ADDENDUM NO. 1

PROJECT NAME: Life Sciences Annex – North and East Wing Renovations
UNL PROJECT NUMBER: A090P025 & A090P026

DATE OF ISSUANCE: February 6, 2012
DATE OF BID OPENING: Tuesday February 14, 2012 @ 2:00 p.m. CDT

Basement Mechanical Room Demolition Plan
 Supplemental Drawing: SDPM-001
 Revision of Sheet: N/A
 Date: 02/03/12

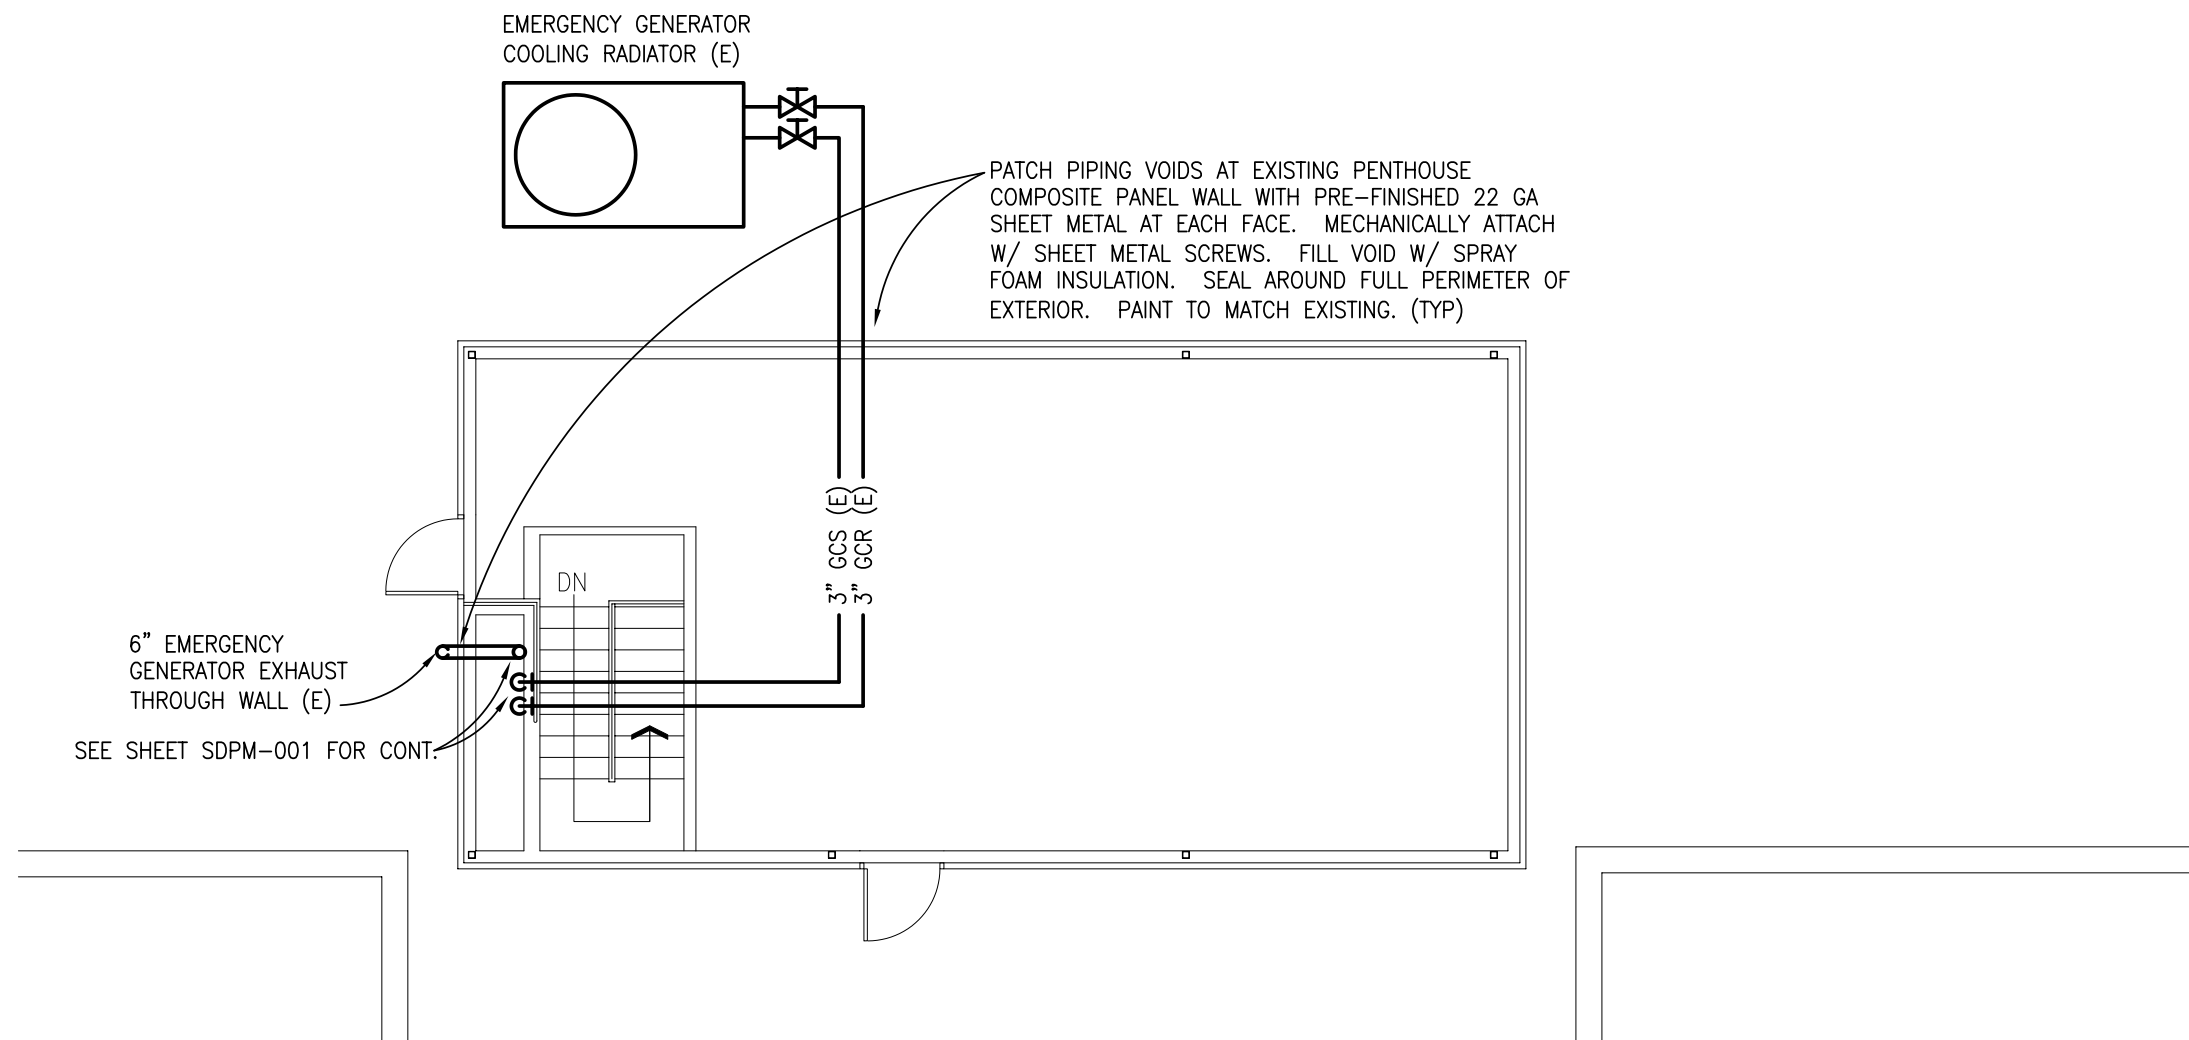
See attached supplemental drawings for mechanical work related to electrical generator removal.

FIRST FLOOR DEMOLITION PLAN AREA 'A'
 SCALE: 1/4" = 1'-0"

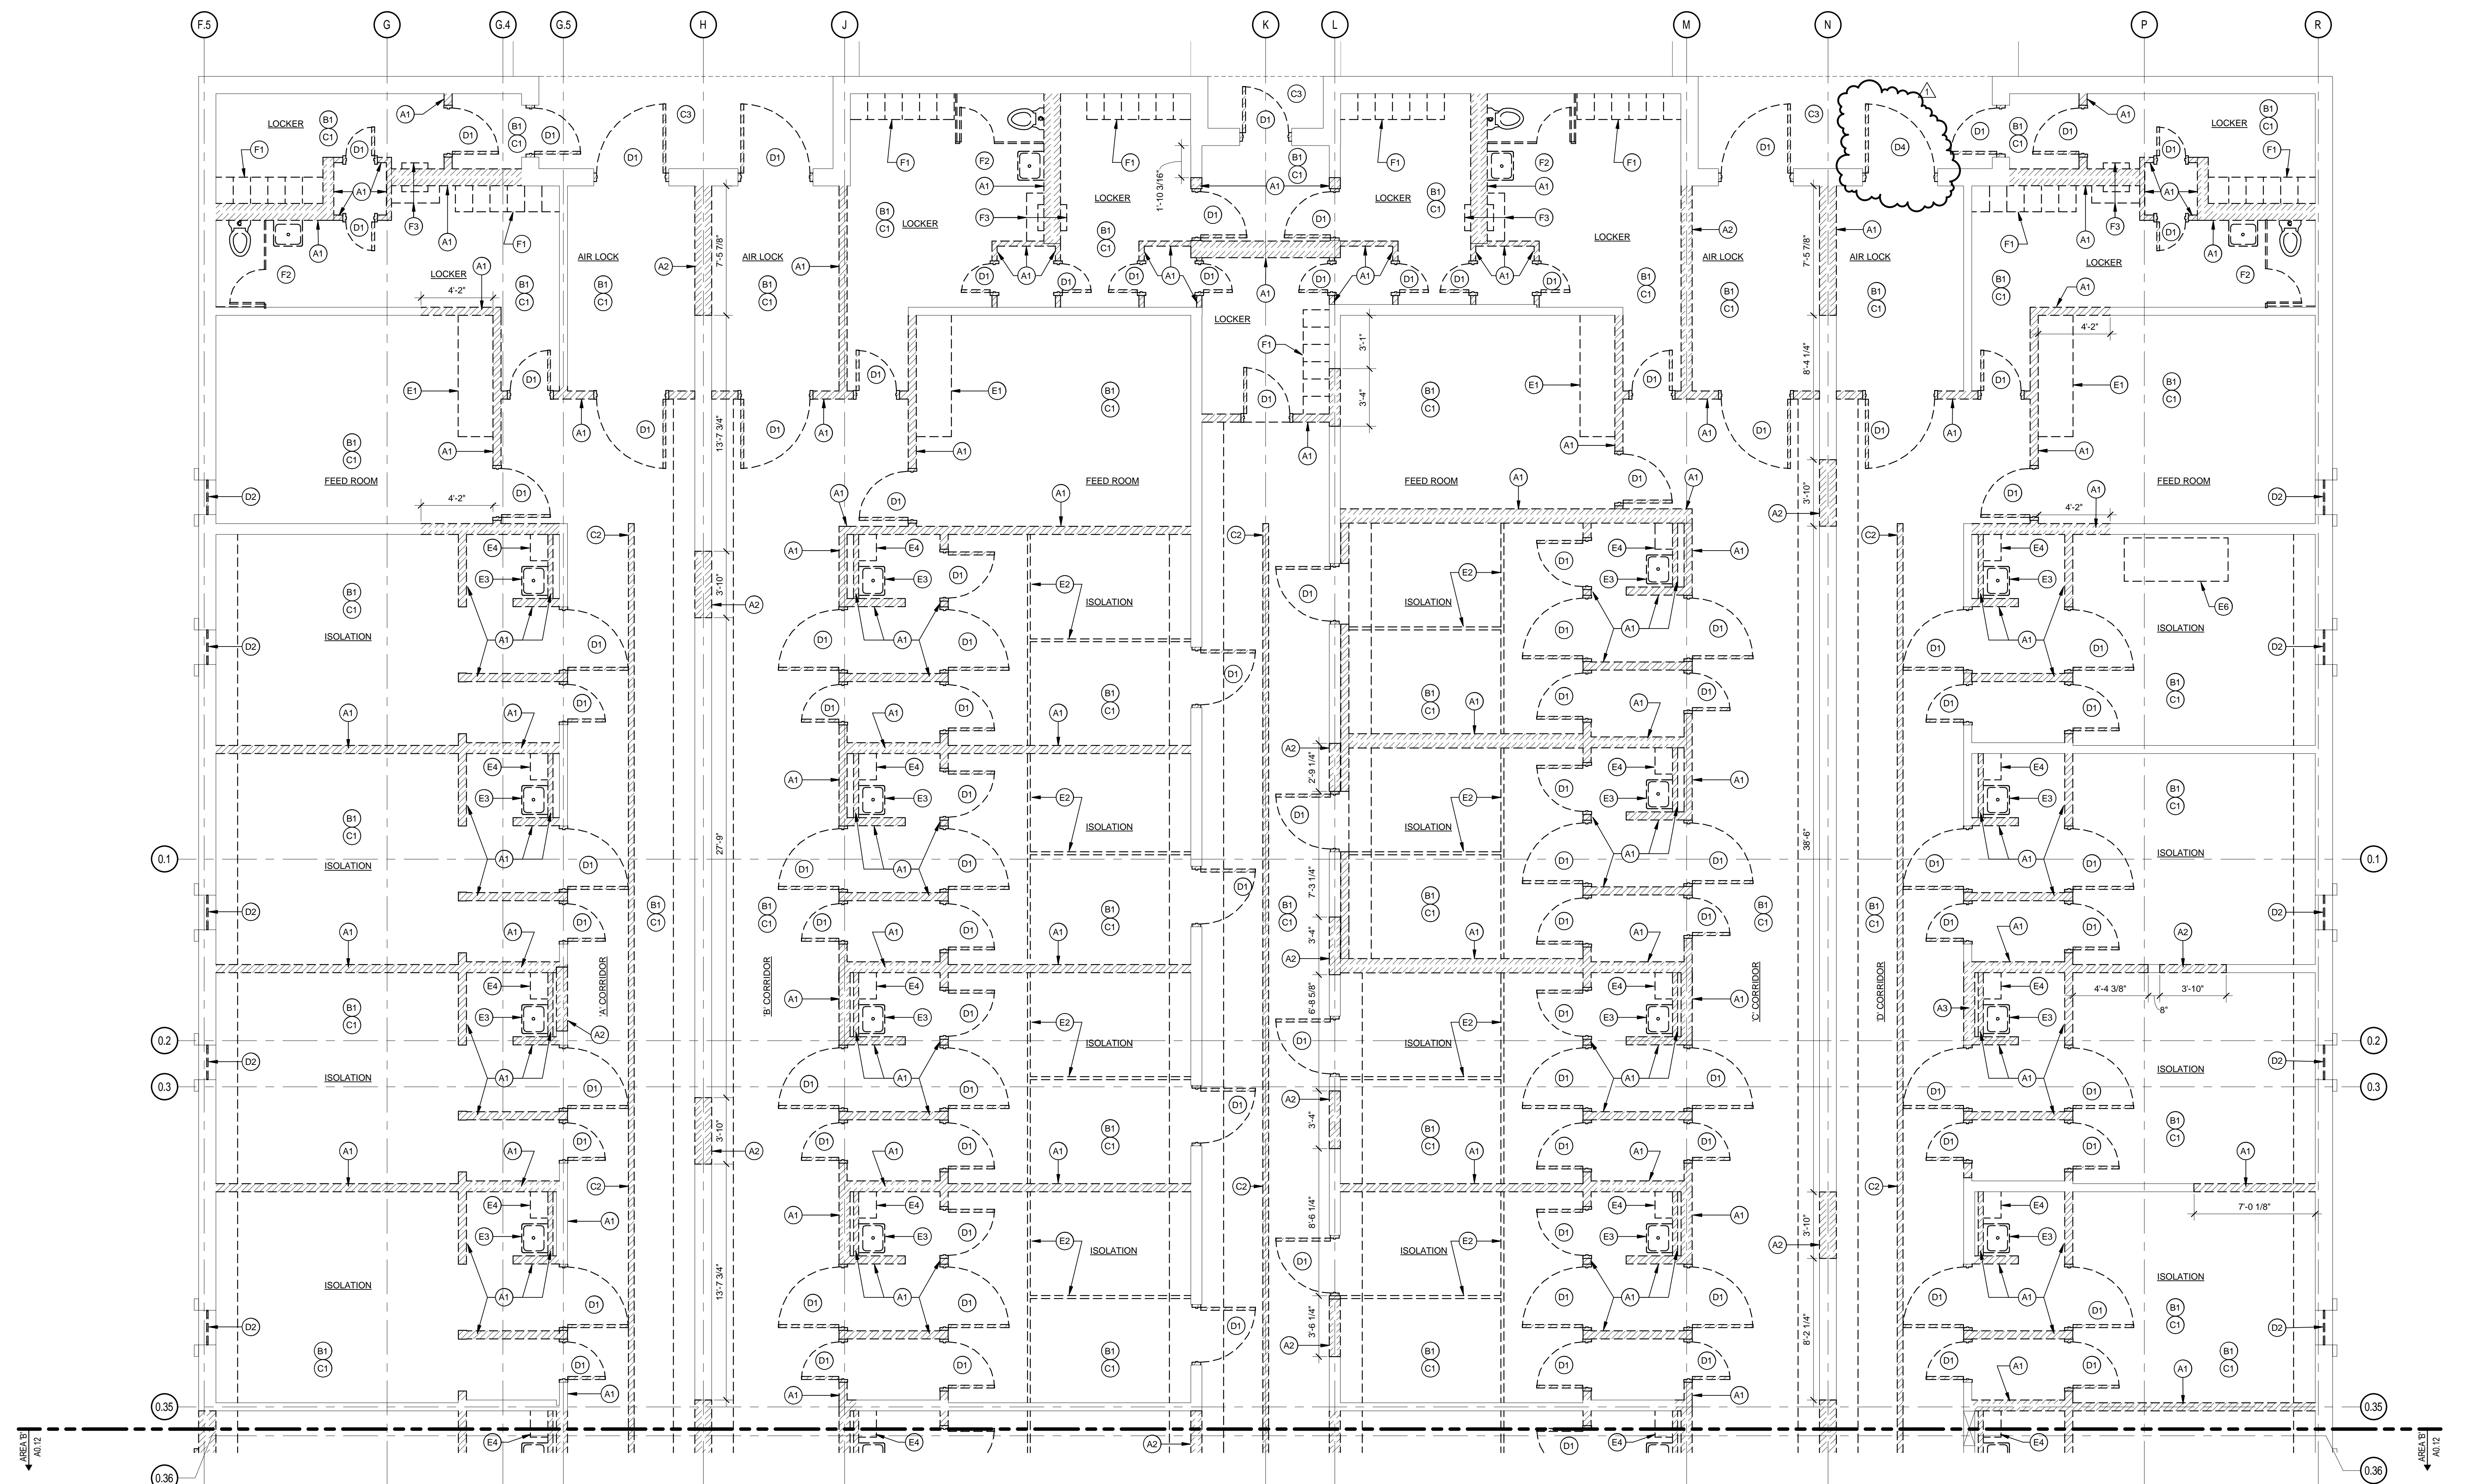
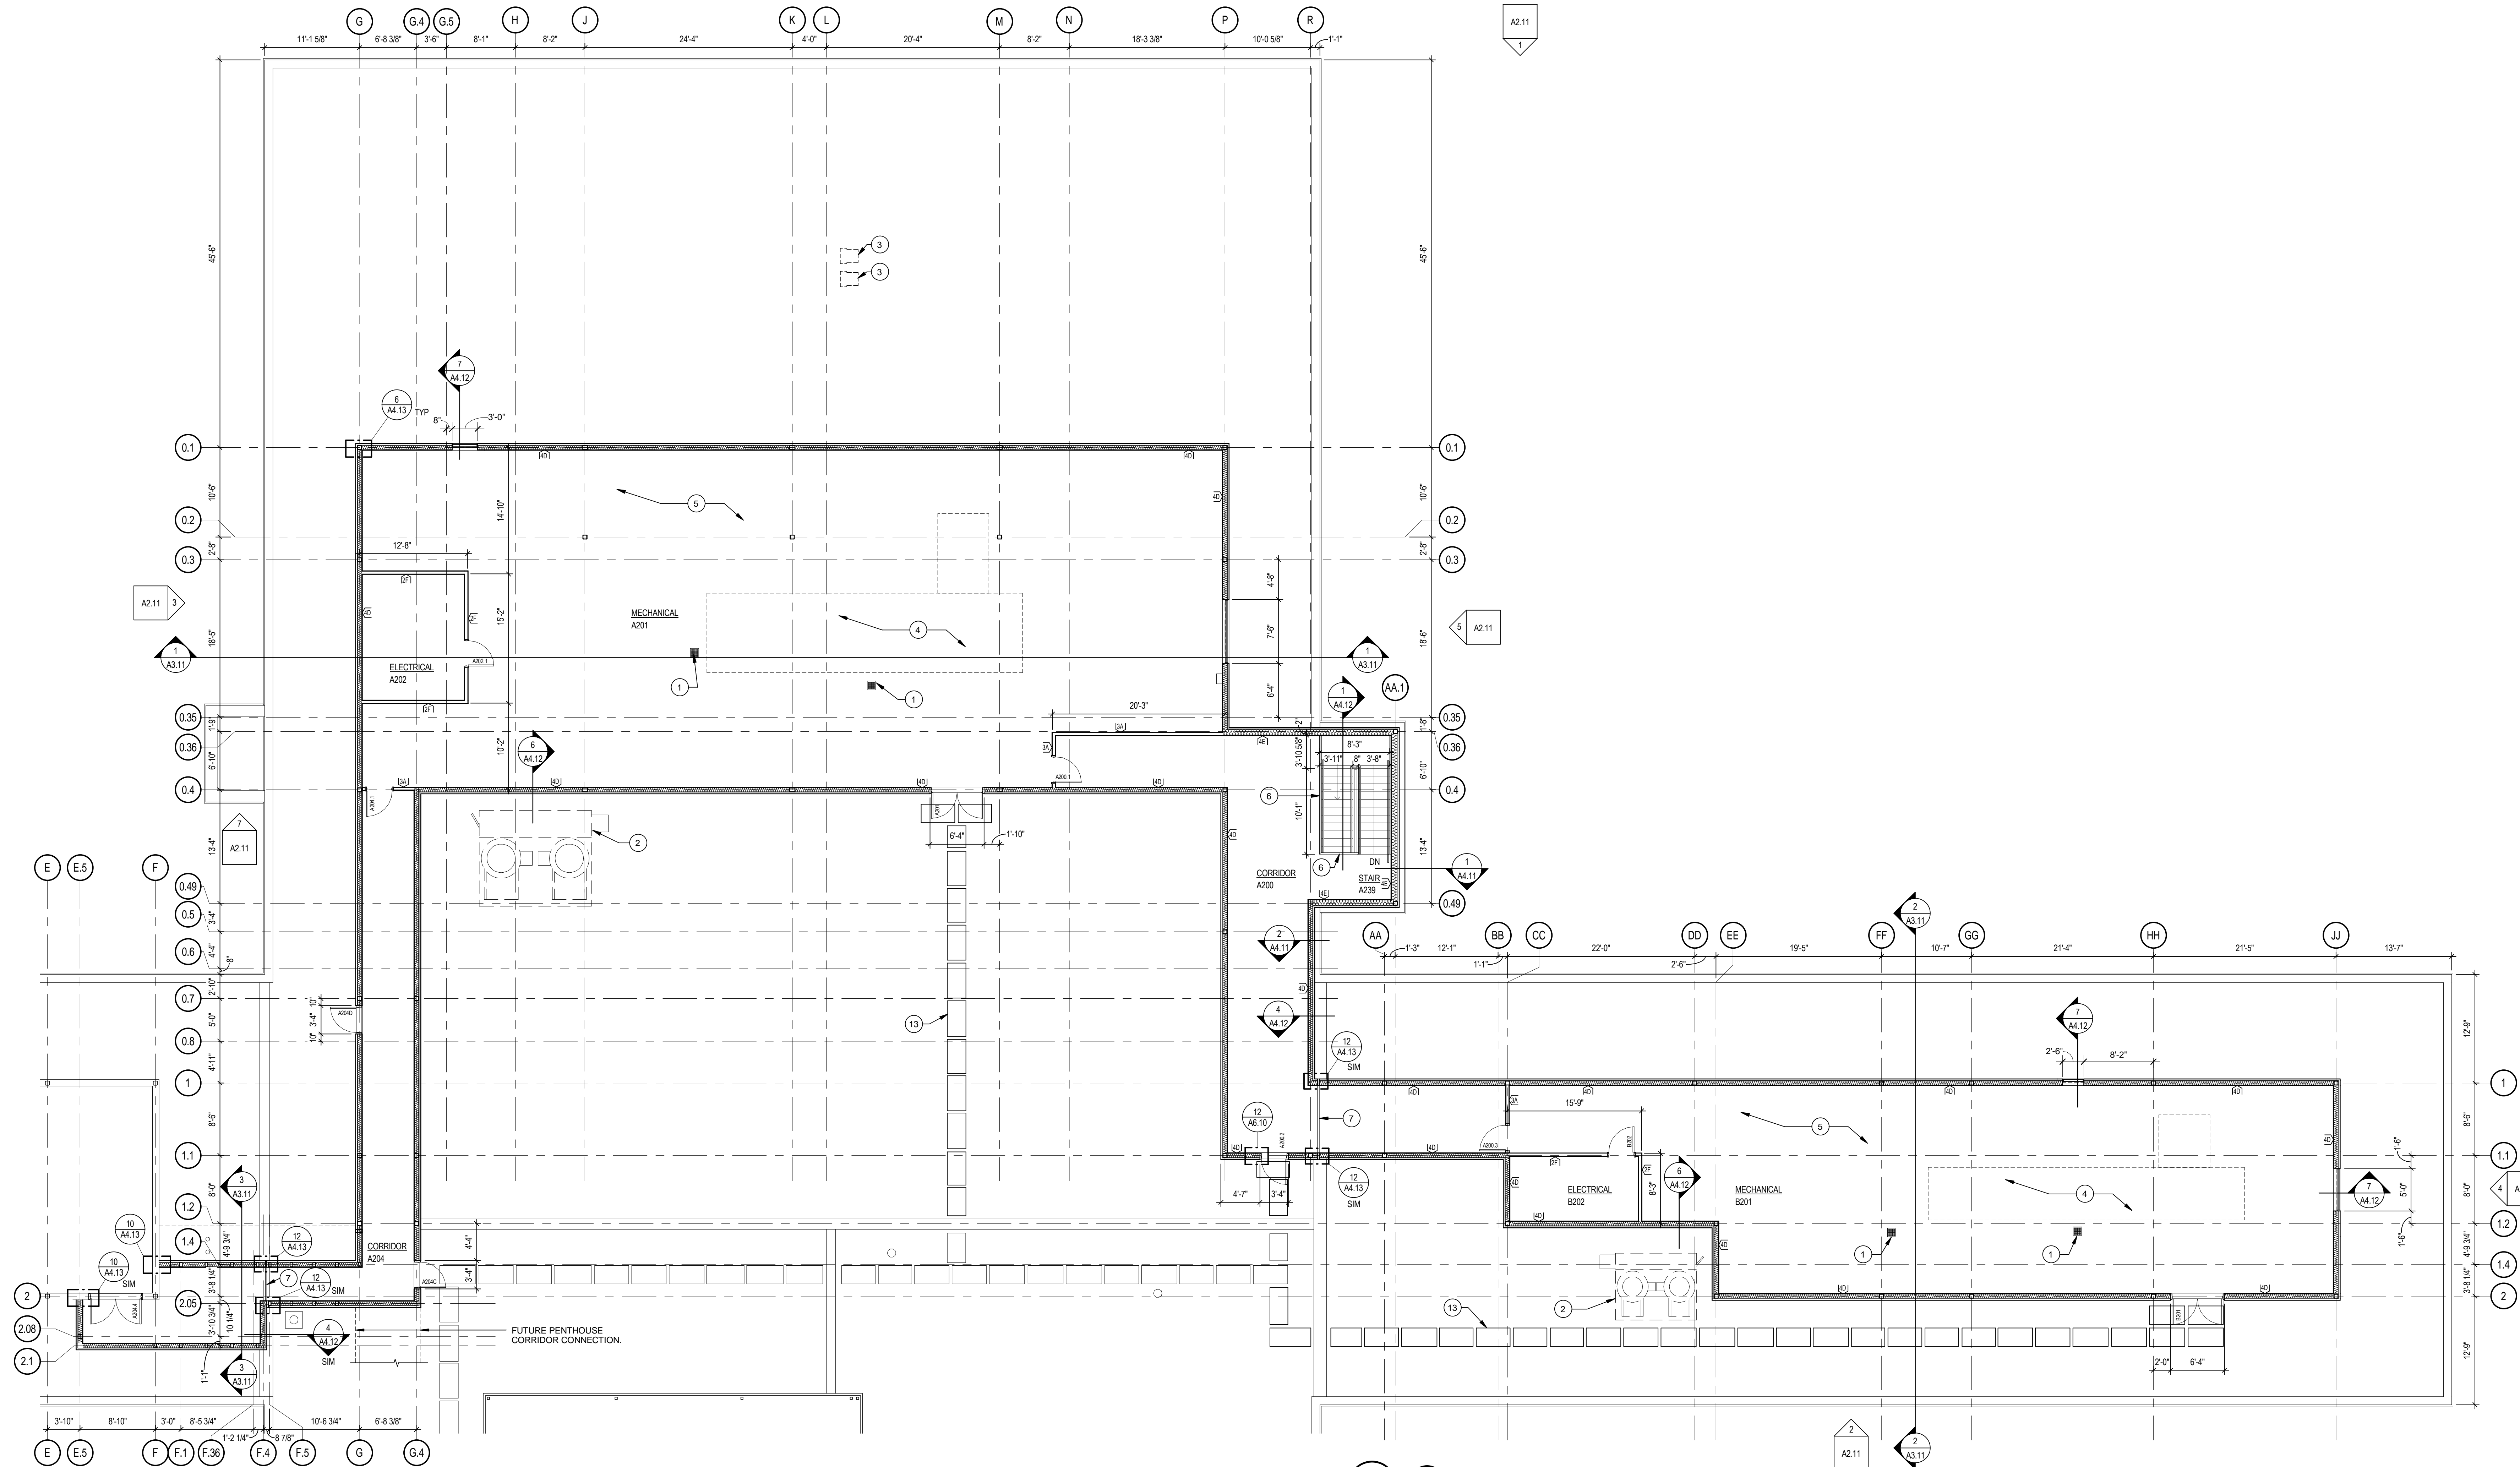
Sheet A0.11 has been updated. See attached reissued sheet with changes indicated.

- ASBESTOS ABATEMENT WILL BE PERFORMED UNDER SEPARATE CONTRACT. IF ASBESTOS IS DISCOVERED DURING DEMOLITION, NOTIFY THE UNL PROJECT MANAGER.
- REMOVE ALL SURFACE MOUNTED OBJECTS IN AREA OF WORK THAT ARE ABANDONED AND NOT INTENDED FOR REUSE. PREPARE SURFACE FOR NEW FINISH.
